# SERVICE LETTER

No. 362B

Piper Aircraft Corporation

Modification of Windshield Top Attachment

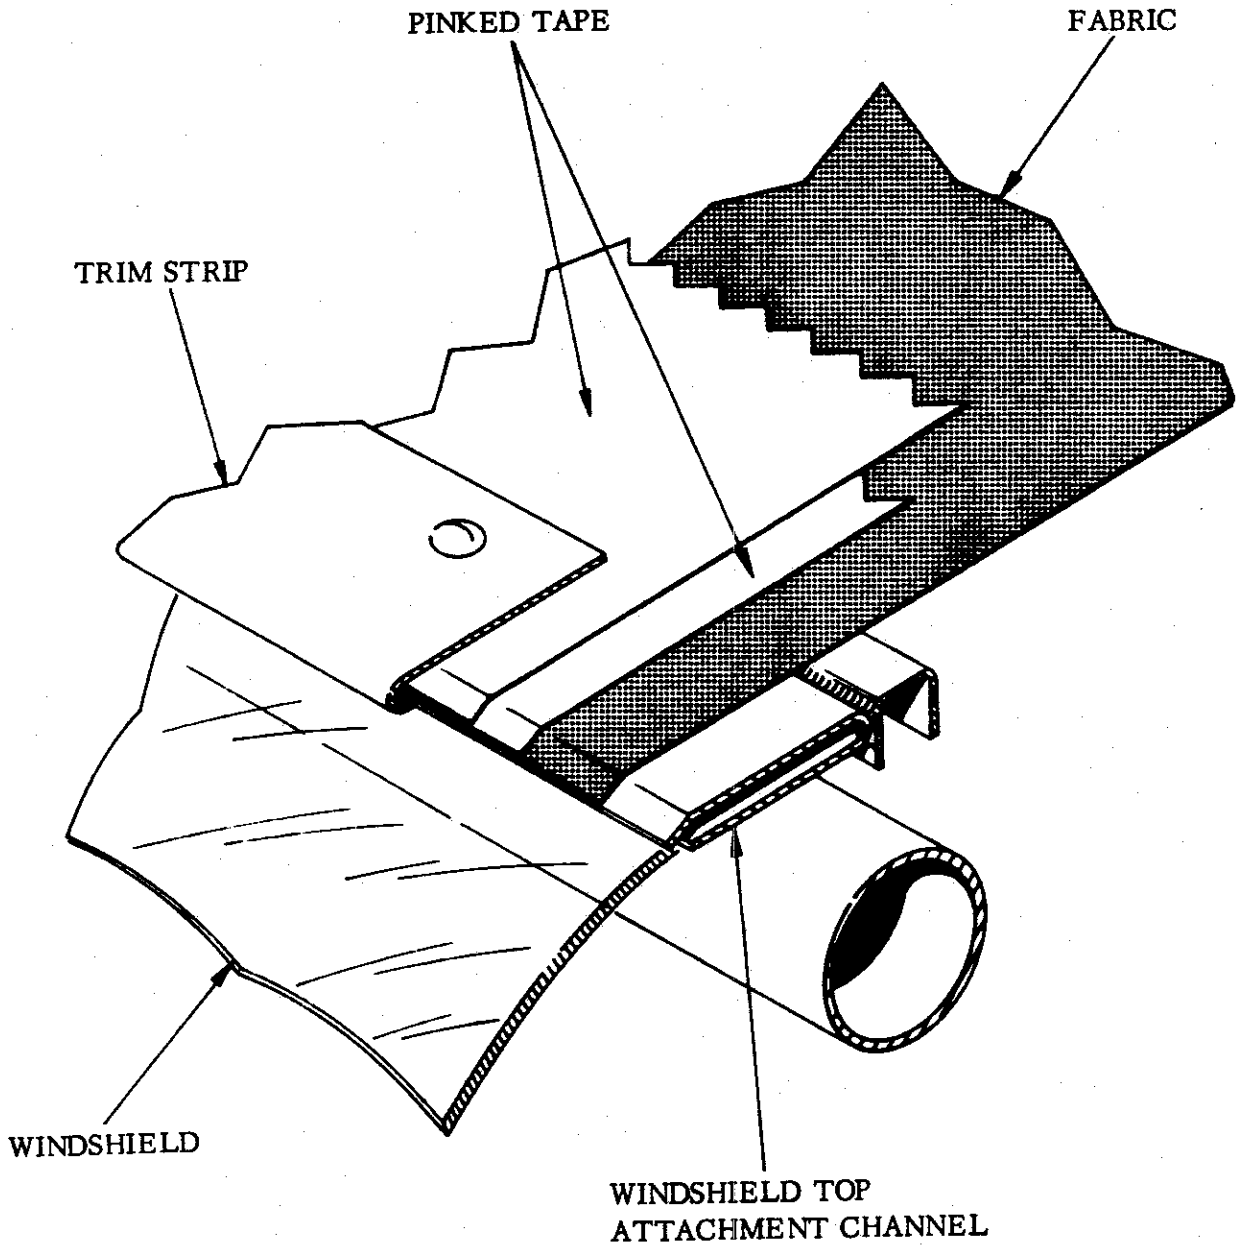
To provide material and instructions to reinforce the area where the fabric attaches to the fuselage under the windshield top and/or directly over the rear edge of the windshield top attachment channel on the above referenced aircraft. The attached sketch illustrates this area.

1. Applies to PA-15, PA-16, PA-17 and PA-20 aircraft listed above, and PA-22 aircraft serial numbers 22-1 to 22-7630 incl.: One (1) each per aircraft Fuselage Fabric Trim Strip Installation Kit, Piper part number 754 404, at \$ suggested unit retail price.
2. Applies to PA-12 and PA-14 aircraft listed above: One (1) each per aircraft Fuselage Fabric Trim Strip Installation Kit, Piper part number 760 799, at \$4.58C suggested unit retail price.
